**PLAN COMMISSION MEETING
IN PERSON AND VIA ZOOM
TUESDAY, JUNE 23, 2026 – 4:00 PM
CITY HALL – SECOND FLOOR**

SITE PLAN REVIEW REPORT TO THE PLAN COMMISSION

Preliminary CSM Review REPORT TO THE PLAN COMMISSION

CERTIFIED SURVEY MAP (EXTRA-TERRITORIAL) REPORT TO THE PLAN COMMISSION

PROJECT NO: 210856
SHEET NO: 1 of 4

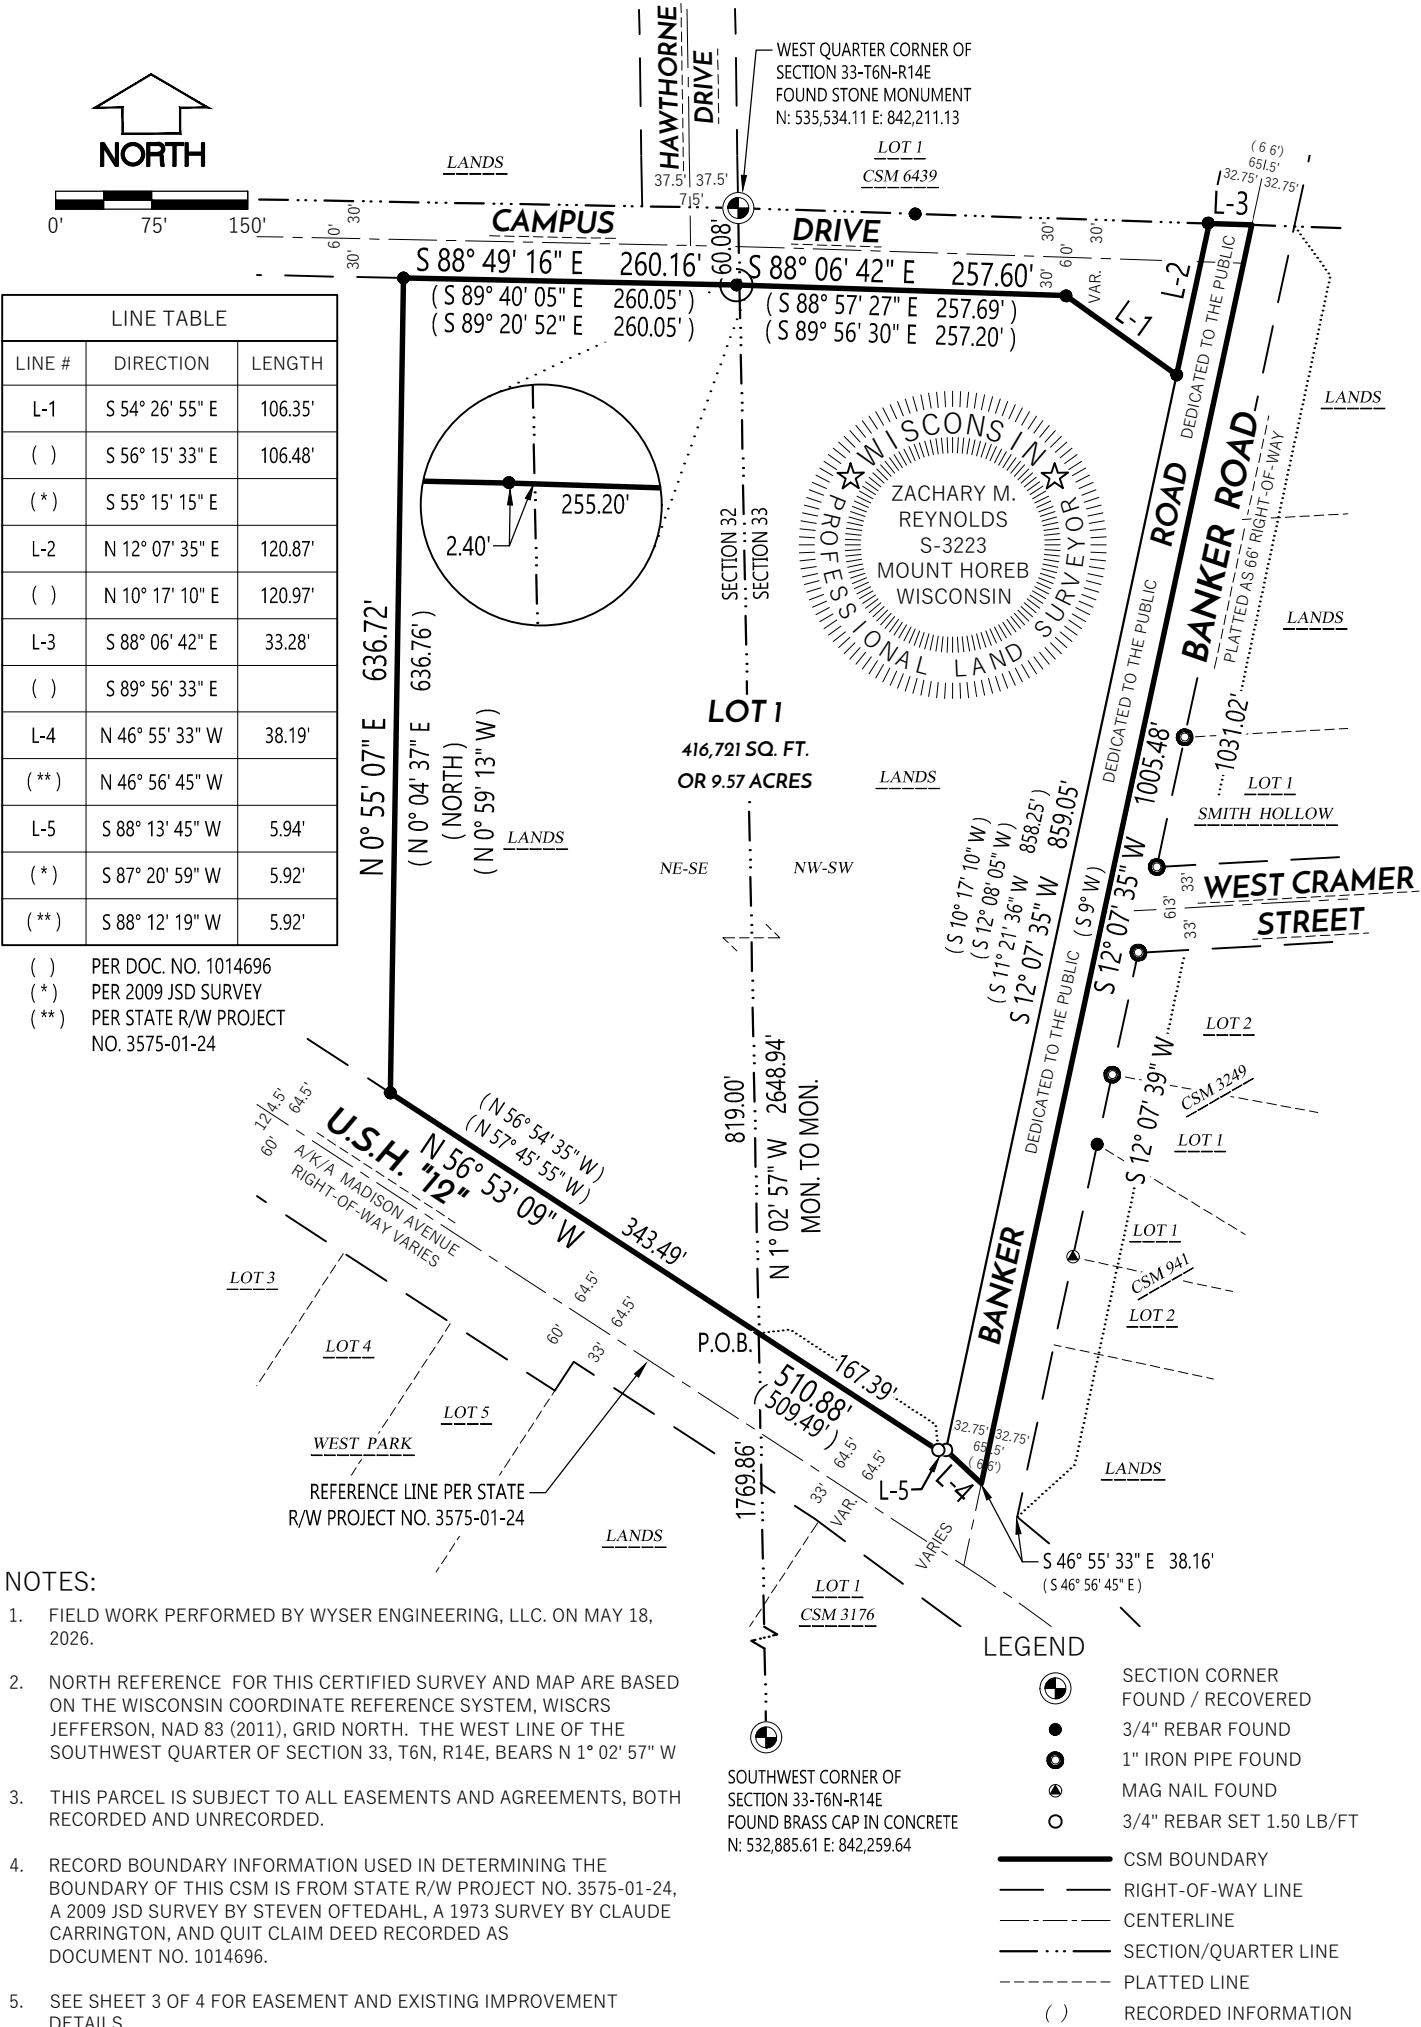
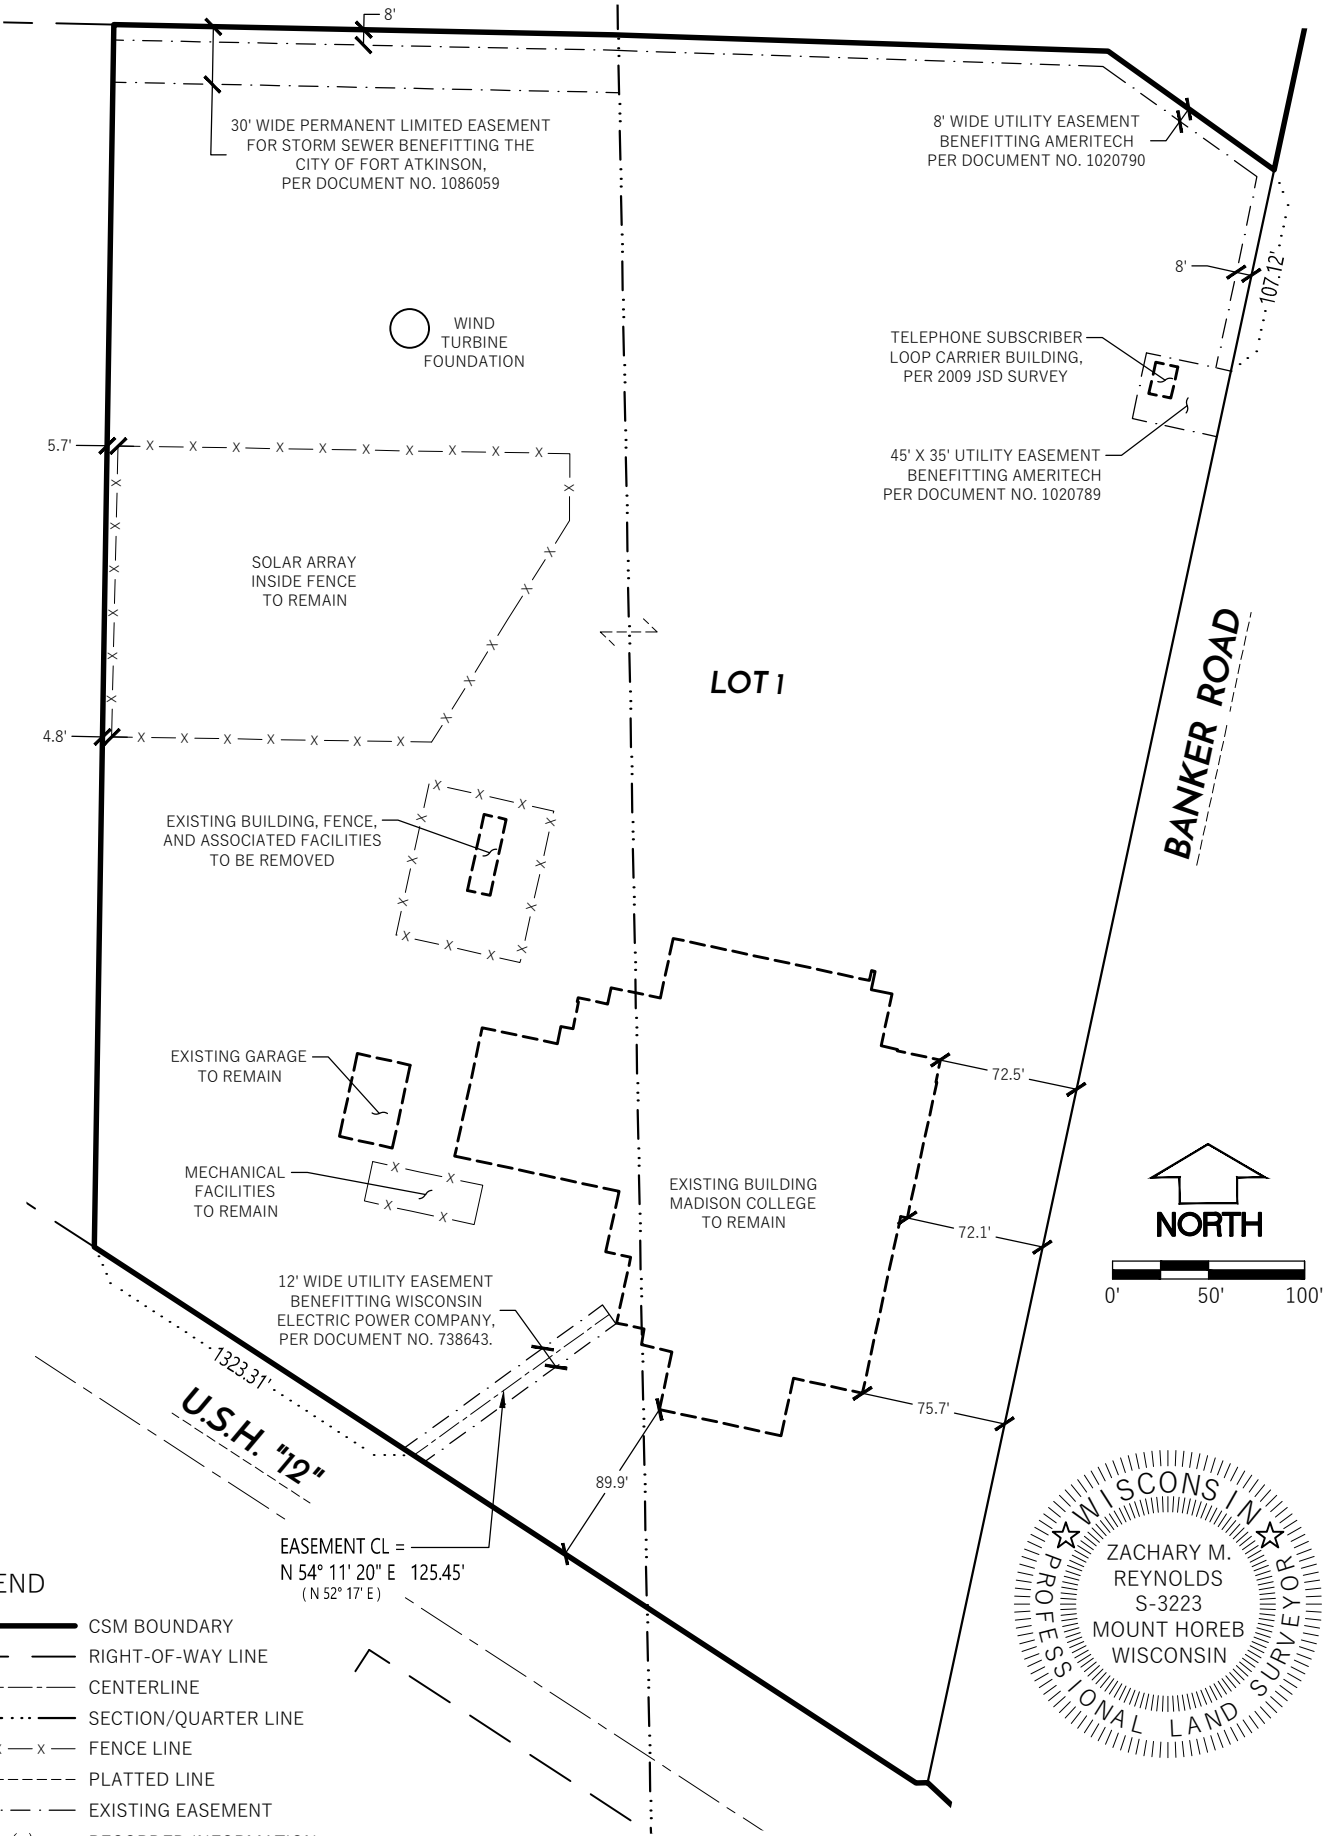
- s. 236.20(2)(b) The legend for metal monuments shall indicate the kind of metal, the outside diameter, length, and weight per lineal foot of the monuments. *The length of the "Set ¾" rebar" must be shown.*
- s. 236.20(2)(c) The length and bearing of the exterior boundaries, the boundary lines of all blocks, public grounds, streets, and alleys, and all lot lines. *Add the 979.92' total length along the westerly line of Banker Road.*
- s. 236.34(1m)(d) *Surveyor's Certificate: Change lines 3-4 to "...dedicated the lands described hereon and the map is a correct representation of the exterior boundaries of the land surveyed and the division thereof. I further certify..."*

- s. 70.06.01(d) *Inset Map. An inset map of the area concerned showing the general location of the proposed subdivision in relation to U.S. Public Land Survey section and quarter-section lines and abutting and nearby public streets and highways. The inset map shall be oriented on the sheet in the same direction as the main drawing.*

- s. 70.06.01(2)(e) *Adjacent land. Locations and names of any adjoining subdivisions, unplatted lands, etc., shall be included. Show the status of the abutting land west of Lot 1.*

Staff recommends that the Plan Commission recommend the City Council approve this preliminary Certified Survey Map, subject to the following conditions:

CERTIFIED SURVEY MAP NO. _____

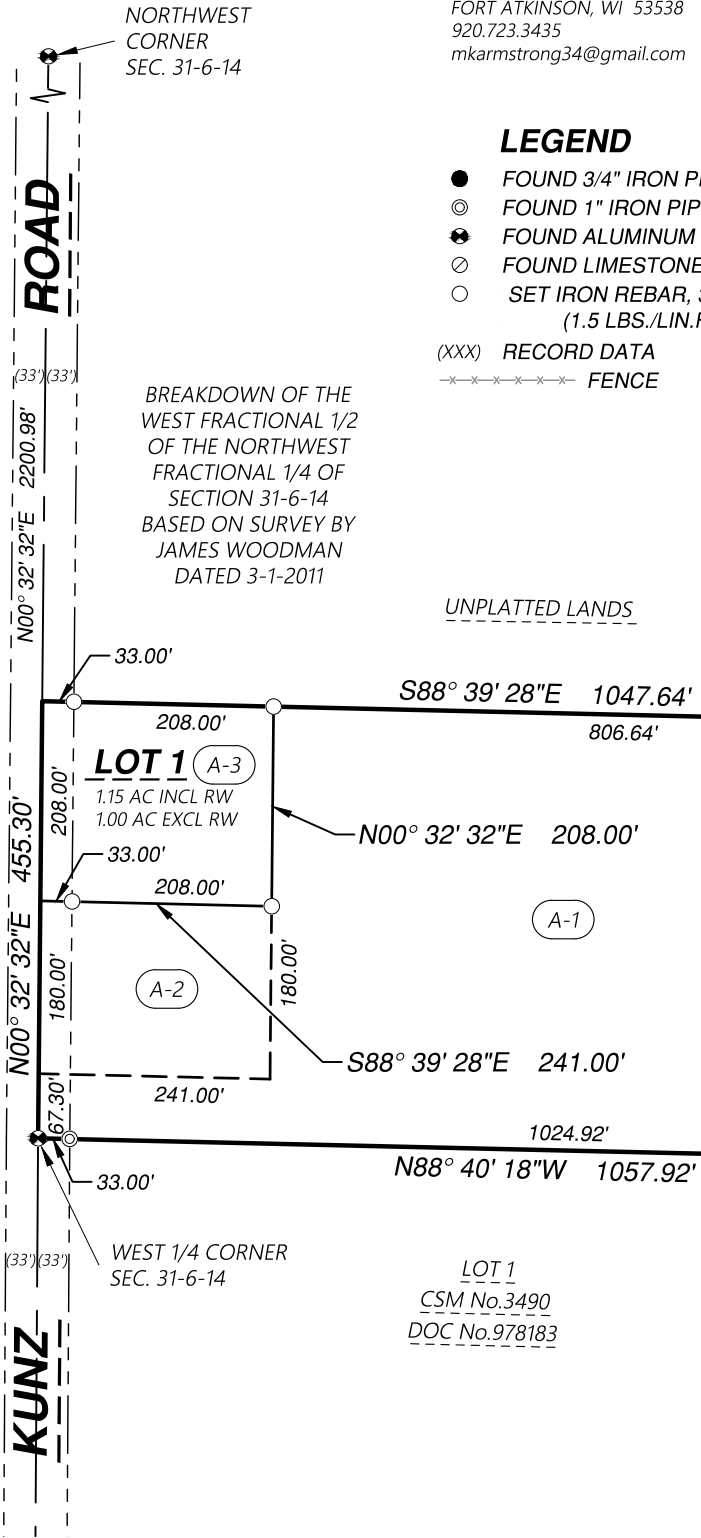
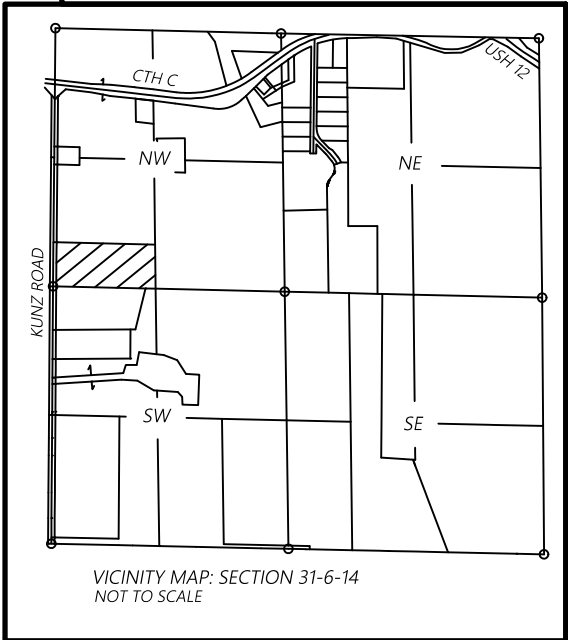
s. 236.34(1m)(a) *Each sheet of the final CSM shall be signed, sealed and dated by a Wisconsin Professional Land Surveyor.*

- 1) *In the Notes on Sheet 1 reference is made to any and all easements recorded and unrecorded. All recorded easements must be shown on the CSM.*
- 2) *The document number for CSM No. 3490 abutting this CSM to the south should be 976183, per Jefferson County GIS.*
